**TOWN OF ERIE  
BOARD OF TRUSTEES MEETING  
June 14, 2016**

**SUBJECT:** Sketch Plan Review of a Proposed Townhome Development in Erie Commons Filing No. 4.

**PURPOSE:** Review of a Sketch Plan for 92 townhome units at the east end of Erie Highlands Filing No. 4.

## Proposed Sketch Plan

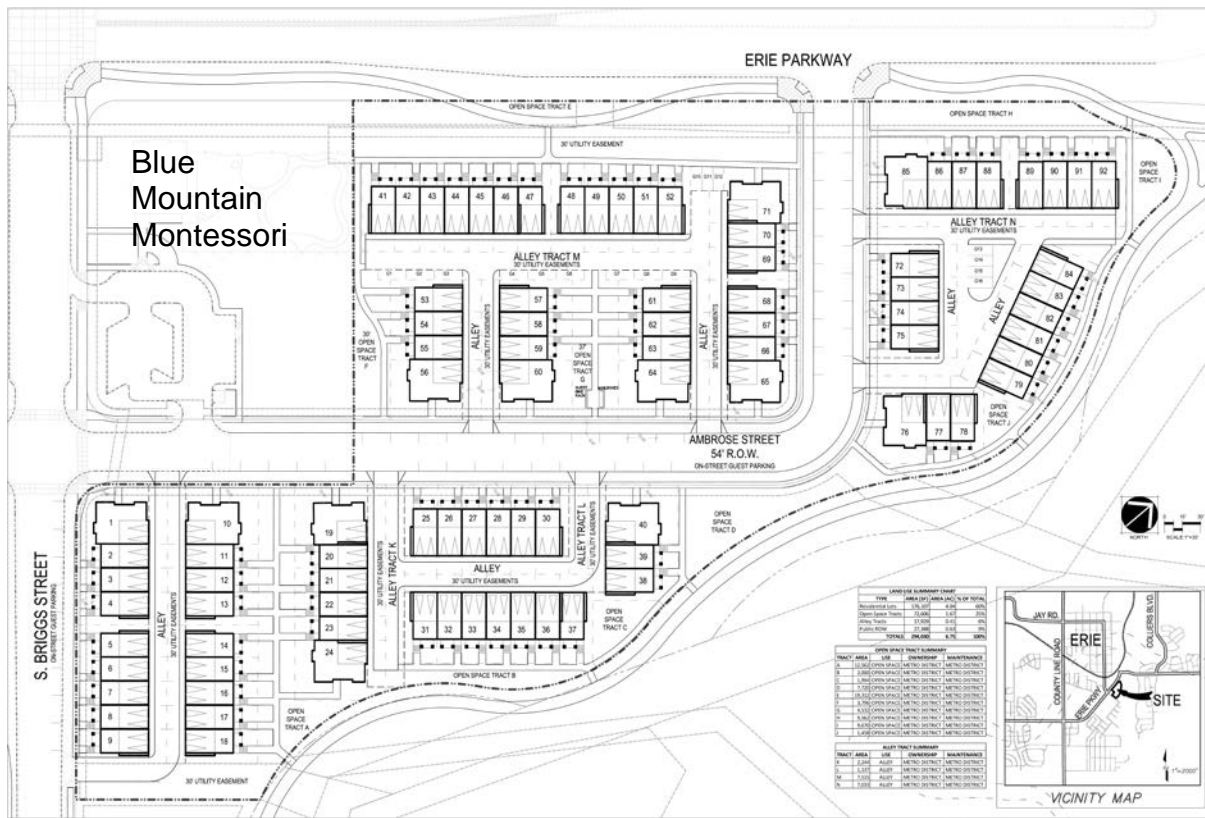
1. Lack of a pocket park.
  - a. The closest park within Erie Commons is beyond our ¼ mile walking distance to a park. Staff recommends that the applicant provide a pocket park.

- b. OSTAB was also concerned over the lack of a pocket park within the proposed development. Please see their attached review comments.
2. Concern over the townhomes facing Erie Parkway.

- a. Staff is concerned with the volume of traffic on Erie Parkway being a problem for the future townhome owners of units oriented with front outdoor porches facing the street. Staff recommends that the majority of units be side loaded to Erie Parkway.

3. Concern over the townhomes adjacent to the Coal Creek spine trail.
  - a. Multifamily development front doors should be oriented to a street or common courtyard that is a minimum of 30 feet wide with walkways that connect to adjacent streets. The applicant submittal faces several units directly onto the Coal Creek spine trail. The Coal Creek spine trail is a regional trail; which is our highest volume trail corridor with the highest speeds. Staff recommends that access onto the spine trail should be limited to distinct access points and setbacks should adhered to so that conflicts between homeowners and trail users can be minimized. Staff is recommending that the majority of units be side-loaded to the spine trail similar to what is proposed in the Sketch Plan on the south end of the development. This allows for views into the

- open space while funneling all users to the spine trail on one common walk system.
- b. OSTAB was also concerned over the orientation and location of the townhomes to the spine trail. Please see their attached review comments.
- 4. Orientation of alley and garages to the Coal Creek spine trail.
  - a. The alley in Tract N extends very close to the spine trail which does not leave much room for landscape screening of the backside and row of garages for dwelling units 89-92. Additionally, staff is concerned about winter snow plowing that would be needed in the alley pushing snow onto the sidewalk system.

Town staff has generally reviewed the proposed Sketch Plan for compliance with the Erie Commons PD requirements and has provided the applicant with detailed comments in the attached staff review memos. Currently, the proposed development does not meet the minimum lot size of 2,000 square feet and the lot setback requirements on all lots. The applicant will need to amend the Erie Commons PD to accommodate the proposed development. The Erie Commons PD Zoning Map and Development Guide are attached for your reference.
